FDR AMENDMENT 1:  
07/30/24

## **Bradley Heights Filing 3 & 4 Final Drainage Report Amendment #1**

STM-REV24-0697 (FDR Amendment #1 Pending)

August 2024

Plan reference: See attached Bradley Heights Filing 4 Storm Sewer Construction Plans (Sheet 3).

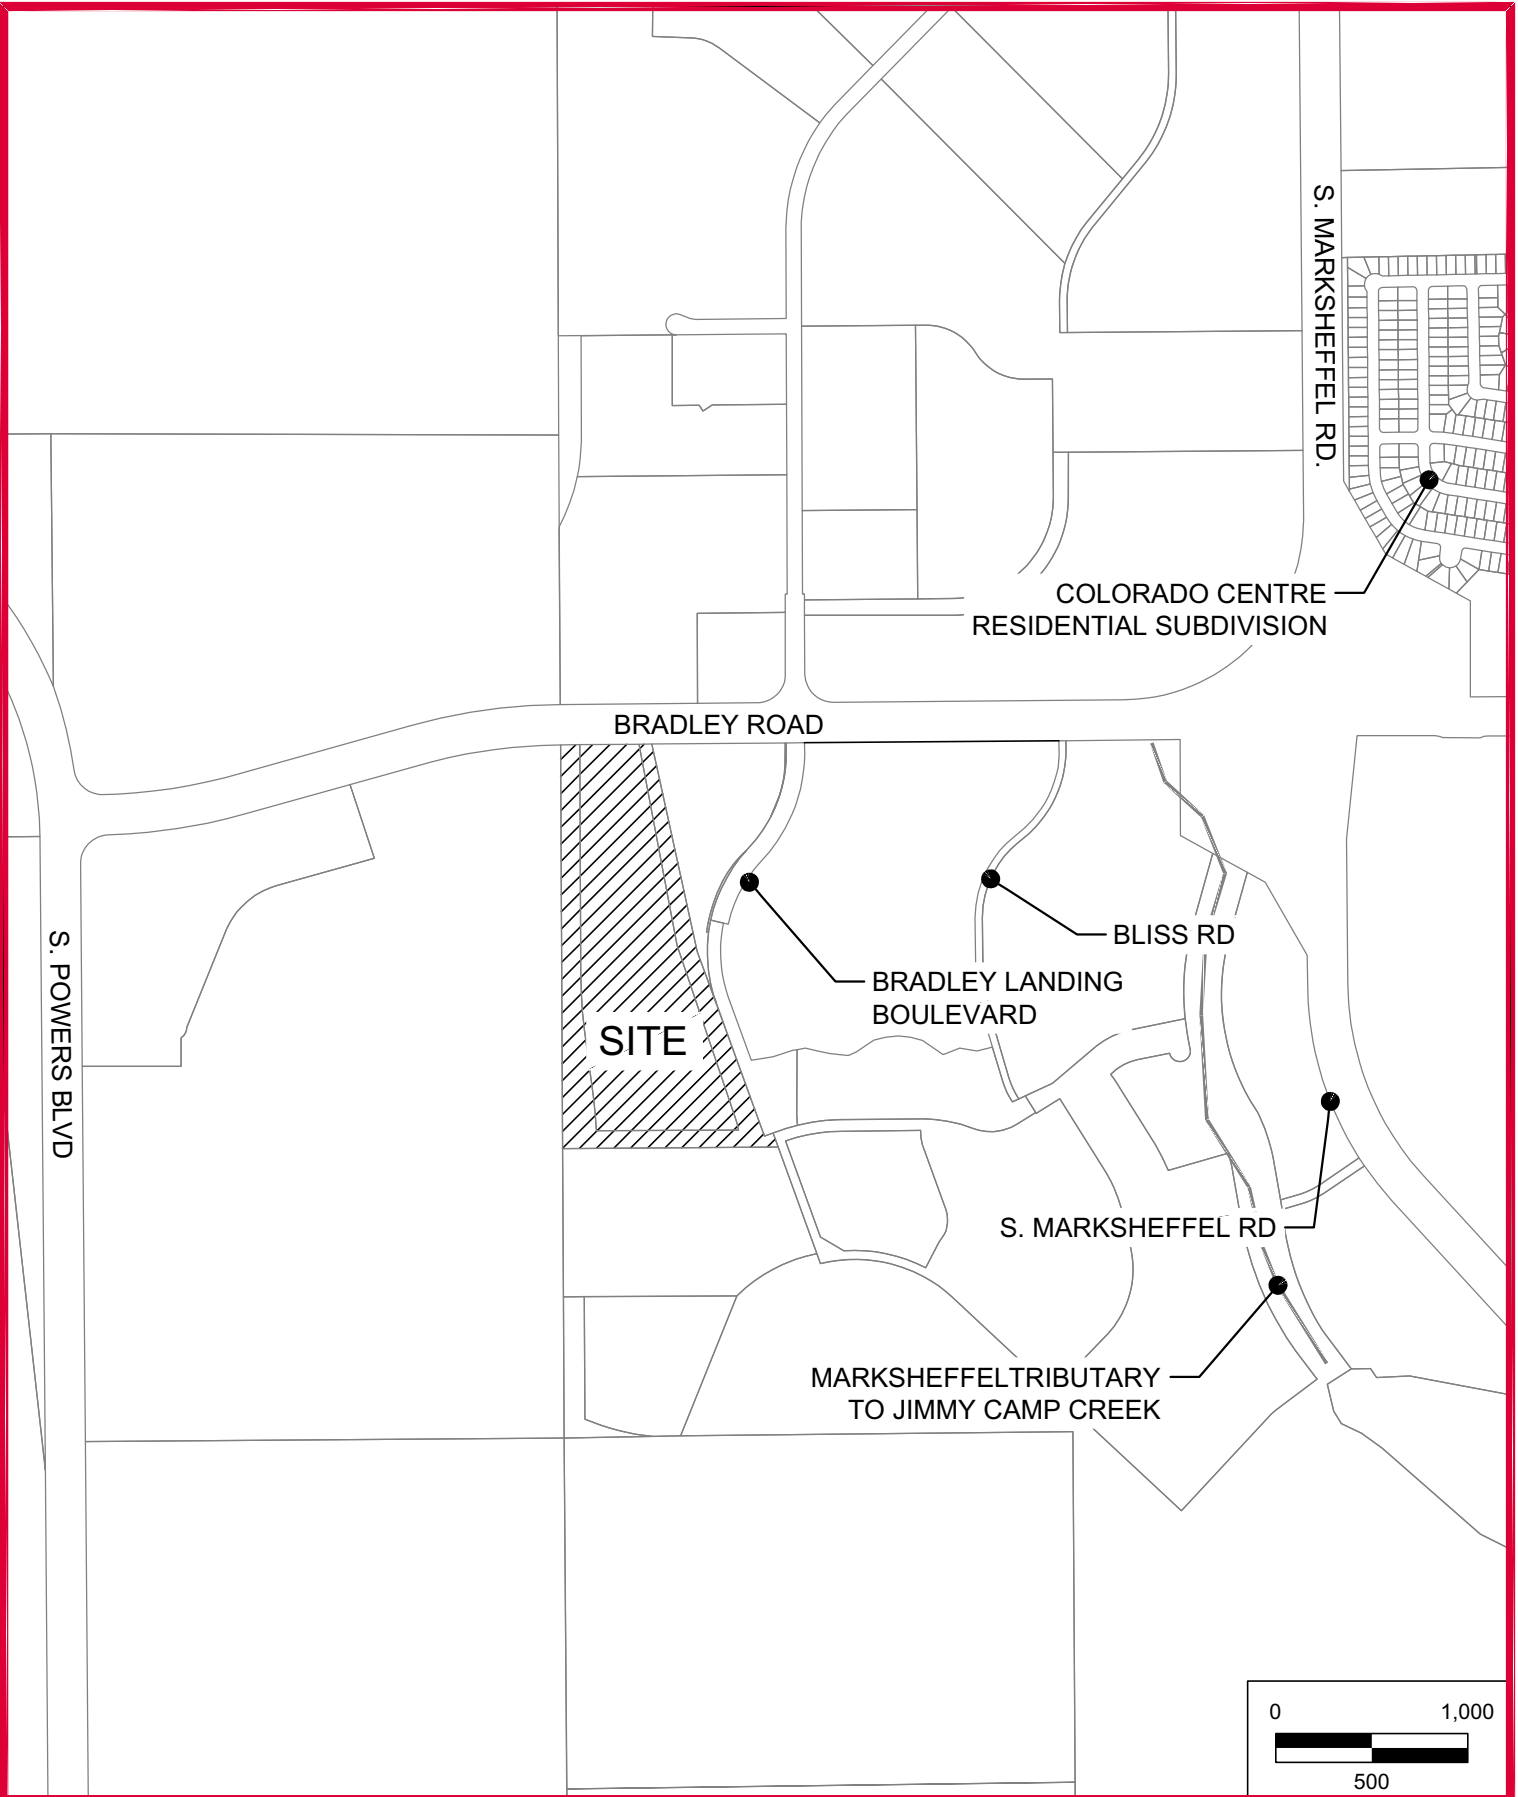
Request for Variance: On behalf of Challenger Communities LLC we are requesting approval of a public Type-R inlet to be used as a junction between a public 24" storm sewer pipe and a public 30" storm sewer pipe.

Reason for Variance: The public Type-R inlet (I-4) is proposed to connect a public 24" RCP to a public 30" RCP which continues and discharges into an onsite pond. The alternative to utilizing I-4 as a junction would require an additional manhole and additional run of pipe to bring the captured stormwater to the stormwater main. Along with the added pipes and structures, two extra utility crossings would be required in this scenario. Therefore the inlet is proposed to be utilized as a junction to reduce the number of manholes and simplify the storm sewer system design in a congested utility location.

Plan reference: See attached Bradley Heights Filing 4 Storm Sewer Construction Plans (Sheets 3 and 4).

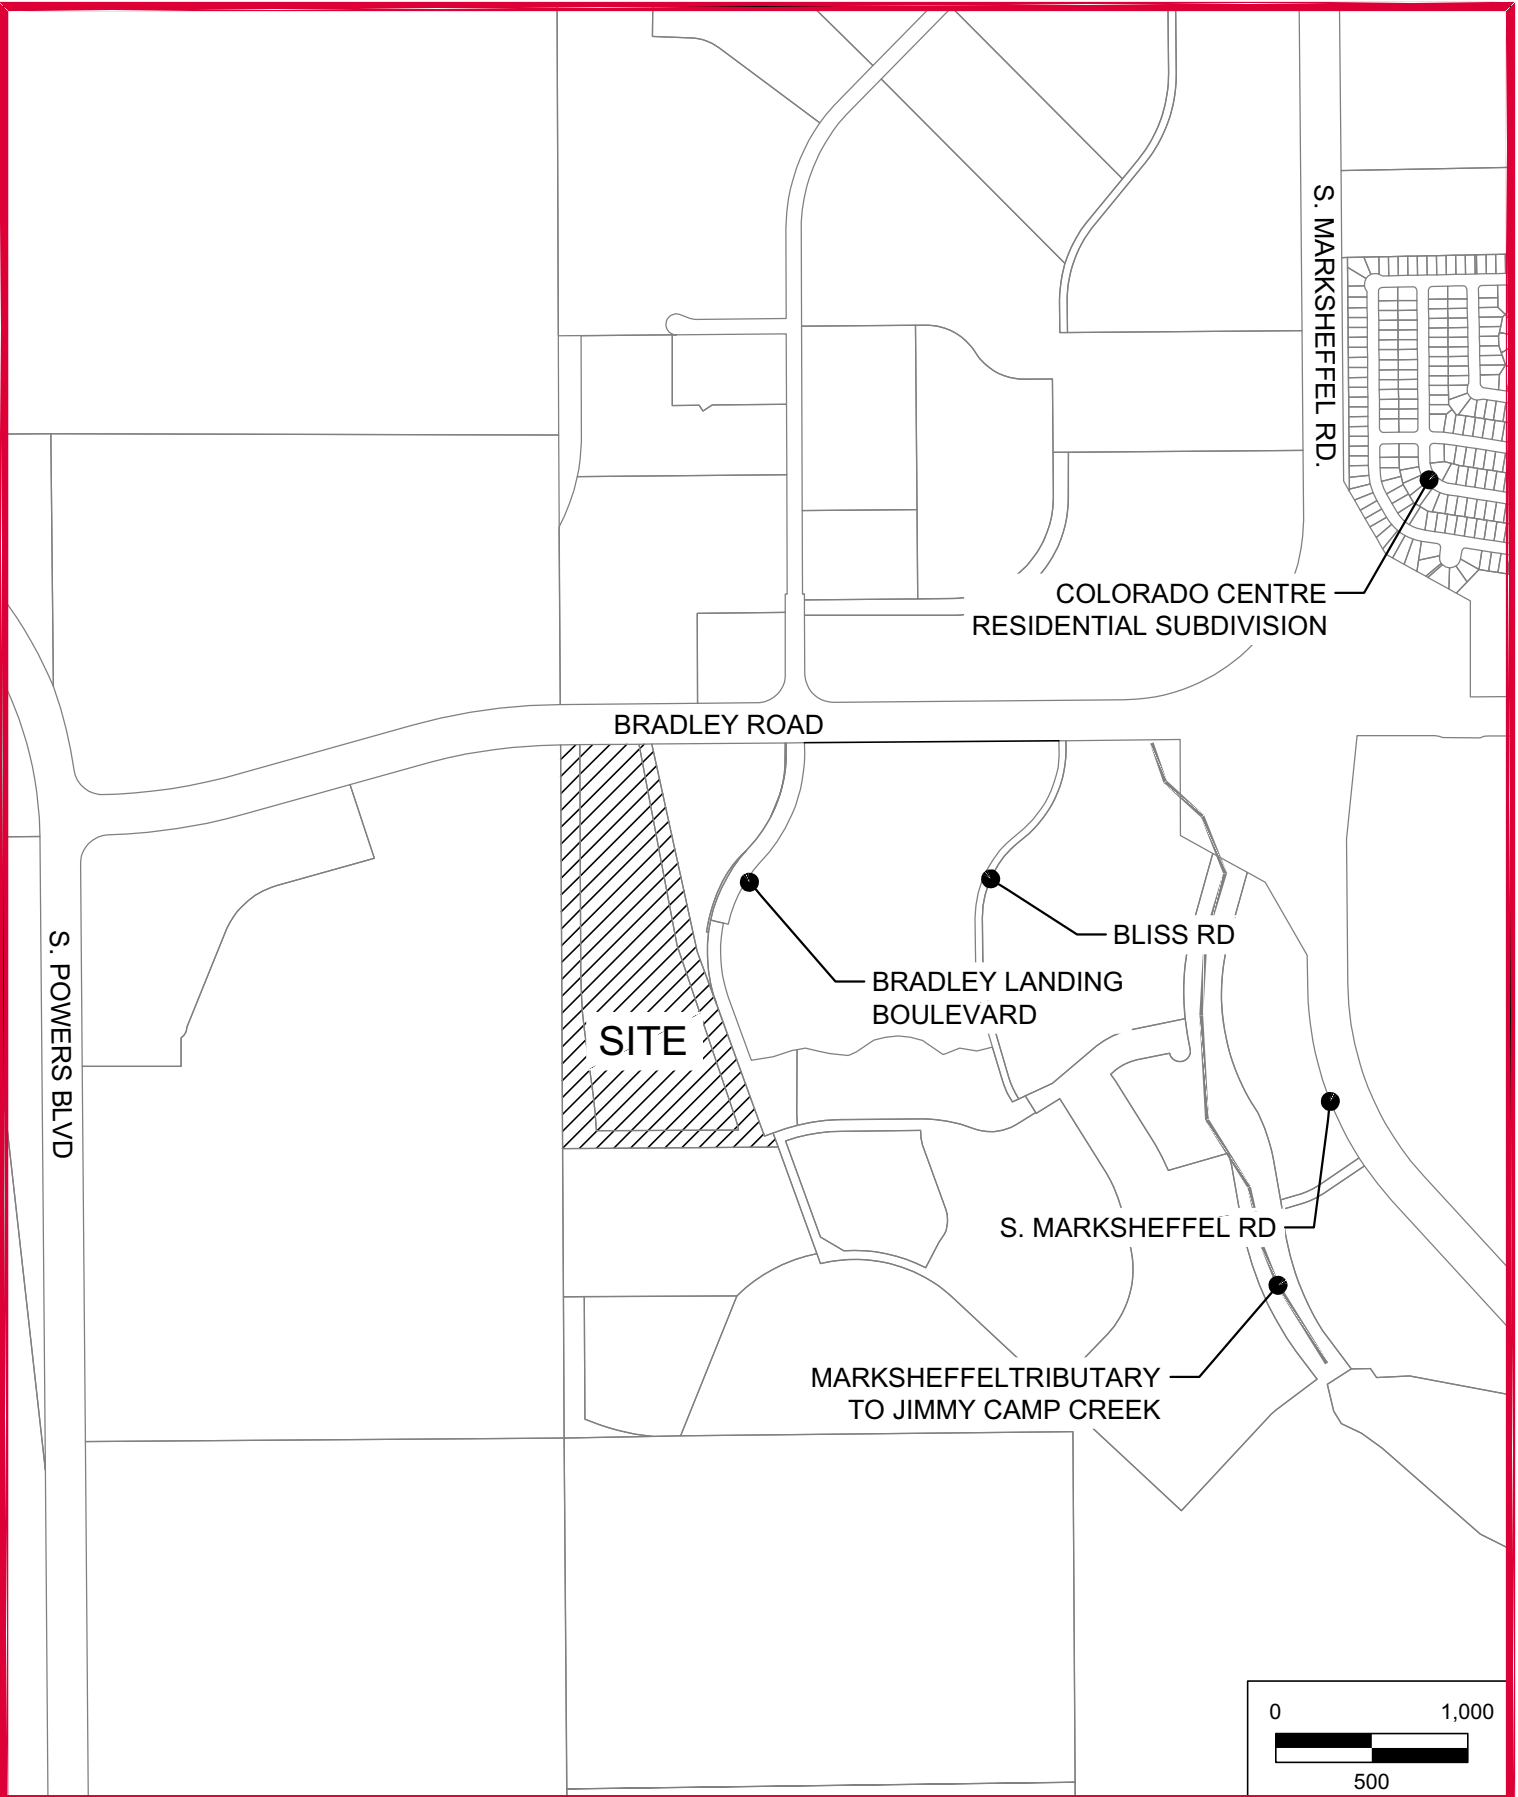
We are in receipt of your review comments dated 03/27/24 for the Bradley Heights Filing 3&4 Development Plan. Per DCM criteria, *“Inlets may not be used as junctions along trunk lines larger than 24” in diameter on public systems.”* We have proposed a public inlet that connects a public 24” pipe to a public 30” pipe. Consolidating this sump inlet location into a junction that carries the stormwater through simplifies the storm design and ease of construction.

Plan reference: See attached Bradley Heights Filing 4 Storm Sewer Construction Plans (Sheets 3 and 4).

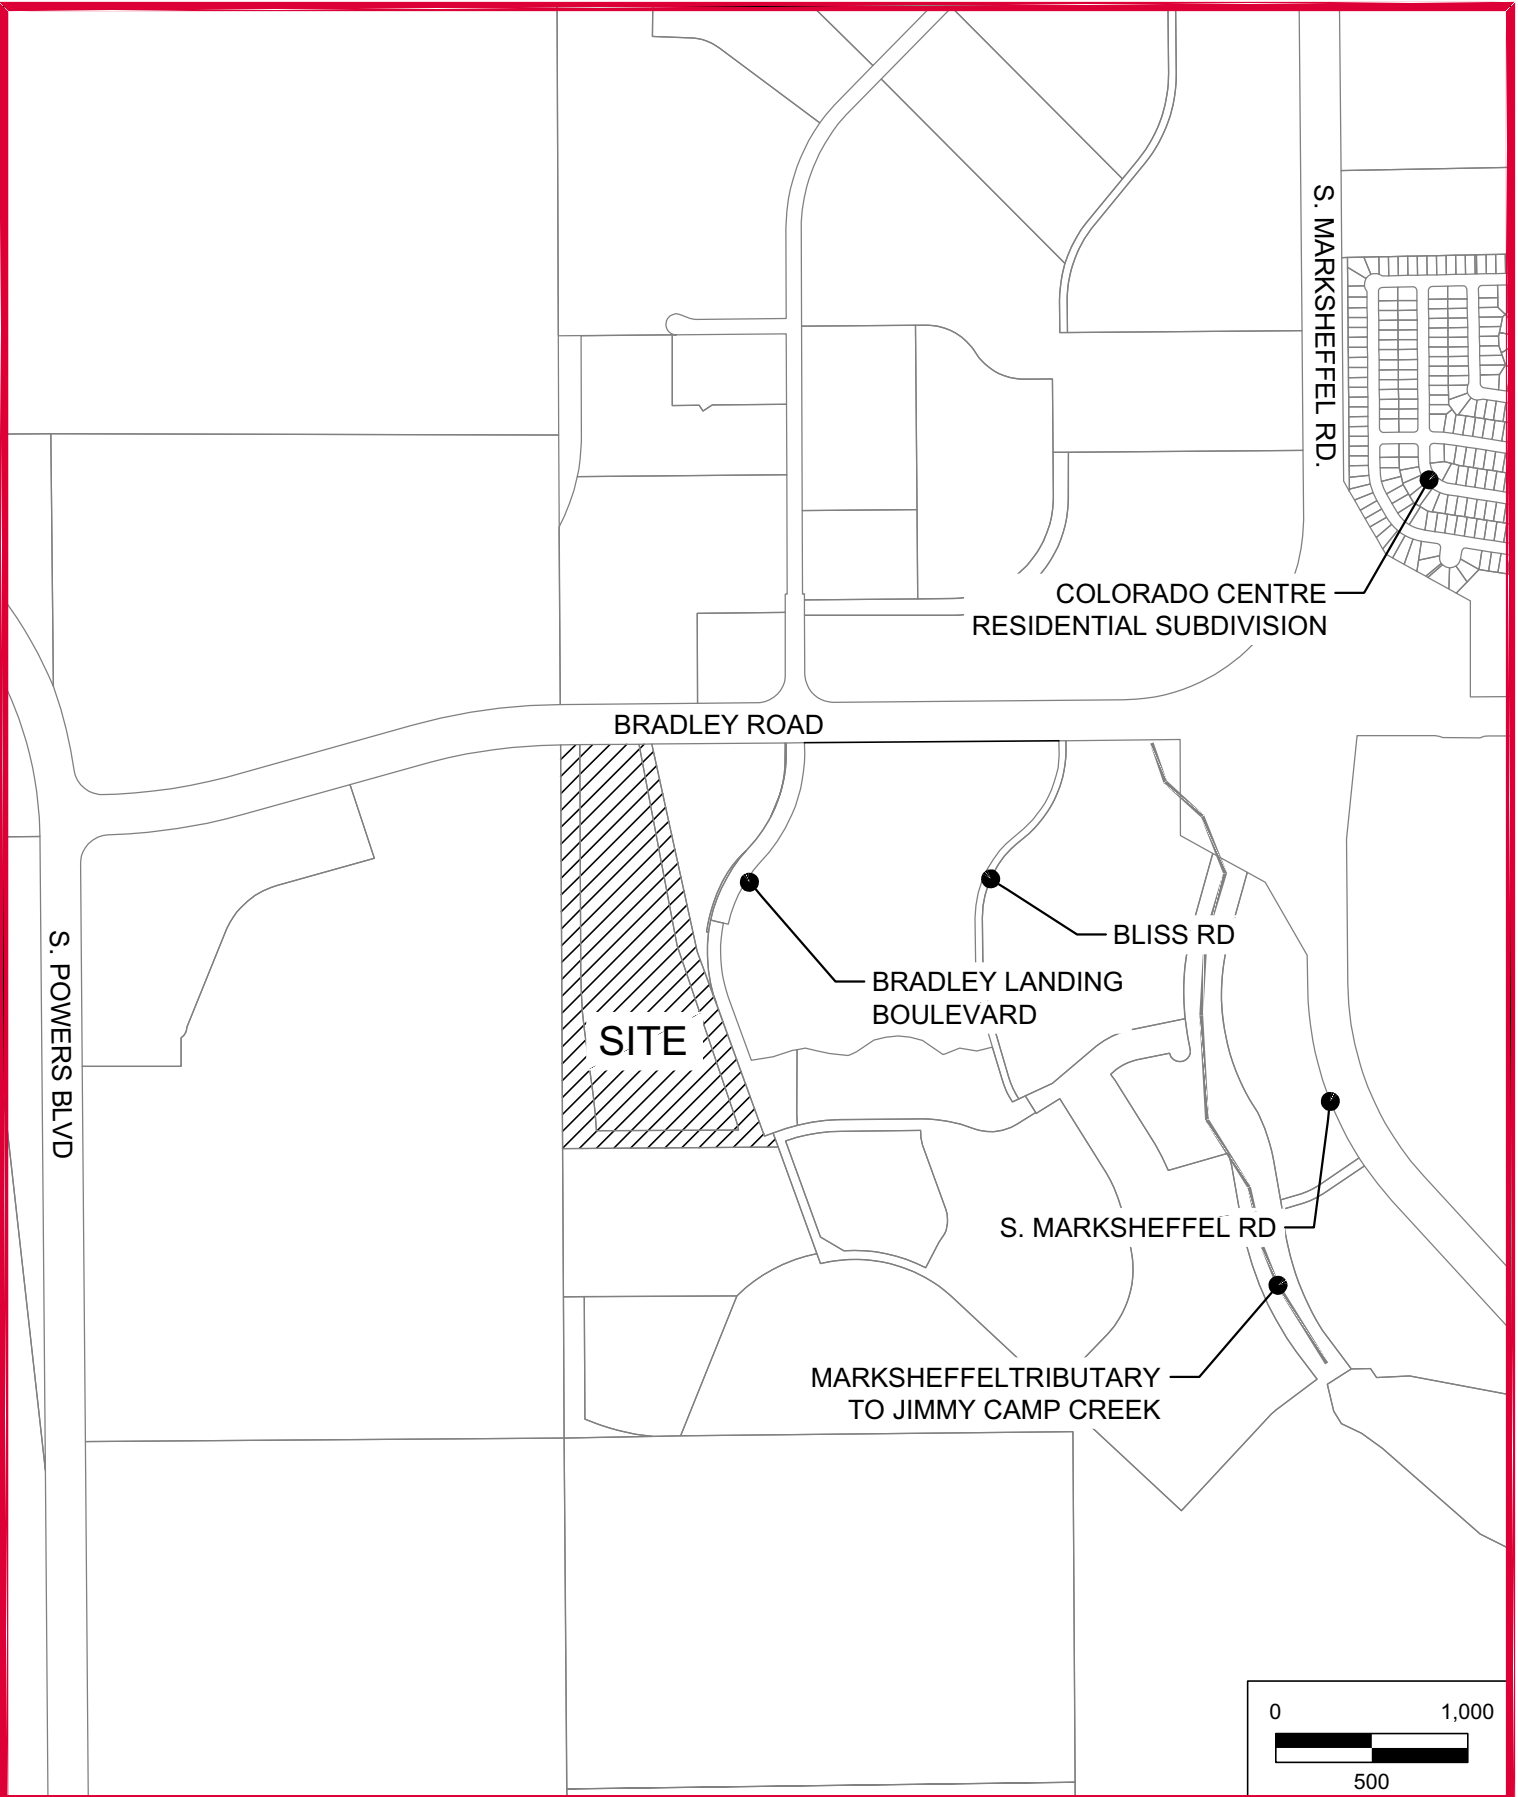
We are in receipt of your review comments dated 03/27/24 for the Bradley Heights Filing 3&4 Development Plan. Per DCM criteria, *"Inlets may not be used as junctions along trunk lines larger than 24" in diameter on public systems."* We have proposed an inlet that connects a 24" pipe to a 30" pipe. Consolidating this sump inlet location into a junction that carries the stormwater through reduces costs and ease of construction. This variance request is summarized below:
